STAFF RECOMMENDATION 1808 Ordway Place June 20, 2012

Application: Appeal of Violation
District: Lockeland Springs-East End Neighborhood Conservation Zoning Overlay
Council District: 06
Map and Parcel Number: 08310023800
Applicant: Lynn Taylor
Project Lead: Robin Zeigler, robin.zeigler@nashville.gov

| <p>Description of Project: Request to keep construction done in violation of permit #2012-00006, January 19, 2012.</p> <p>Recommendation Summary: Staff recommends disapproval of the request to keep the bricked in windows as the construction is different than what was permitted and the action, rather than making the non-contributing building fit into the historic context better, does the opposite, by creating a blank wall and disrupting the rhythm of openings. Staff finds that the request does not meet permit 2012-00006 and does not meet II.B.7 of the <i>Lockeland Springs-East End Neighborhood Conservation Zoning Overlay: Handbook and Design Guidelines</i>.</p> | <p>Attachments A: MHZC Permit #2012-00006</p> |

Partial drawing from application and permit.

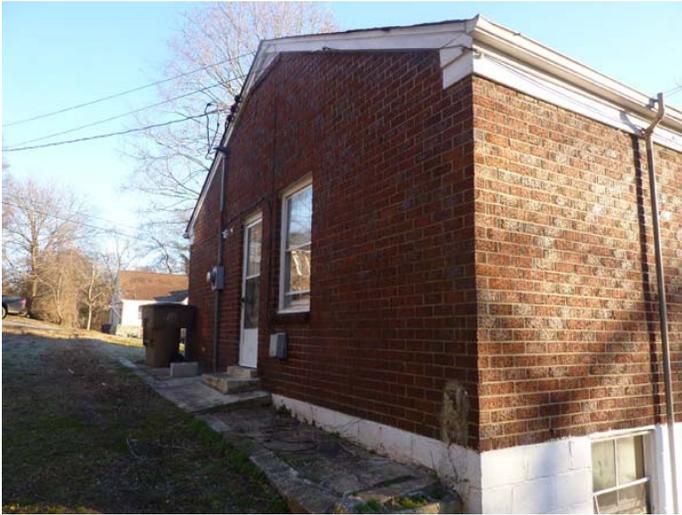
On January 18, 2012 the Commission approved a rear addition, a new front porch and alterations to the existing house. The original application requested keeping the existing right side window and turning the right side door into a window. Staff recommended approval since this was appropriate alteration for a non-contributing house and kept a window pattern that was consistent with historic buildings. The Commission agreed and a permit was issued.

On May 30, 2012, on a regular inspection of the neighborhood, staff discovered that vinyl windows with snap-in muntins had been installed, the porch rack had been shingled over, front windows had been installed that were significantly smaller than the opening, and that two side windows had been completely bricked in, all in violation of the issued permit.

Staff recommends disapproval of the request to keep the bricked in windows as the construction is different than what was permitted and the action, rather than making the non-contributing building fit into the historic context better, does the opposite, by creating a blank wall and disrupting the rhythm of openings. Staff finds that the request does not meet permit 2012-00006 and does not meet II.B.7 of the *Lockeland Springs-East End Neighborhood Conservation Zoning Overlay: Handbook and Design Guidelines*.
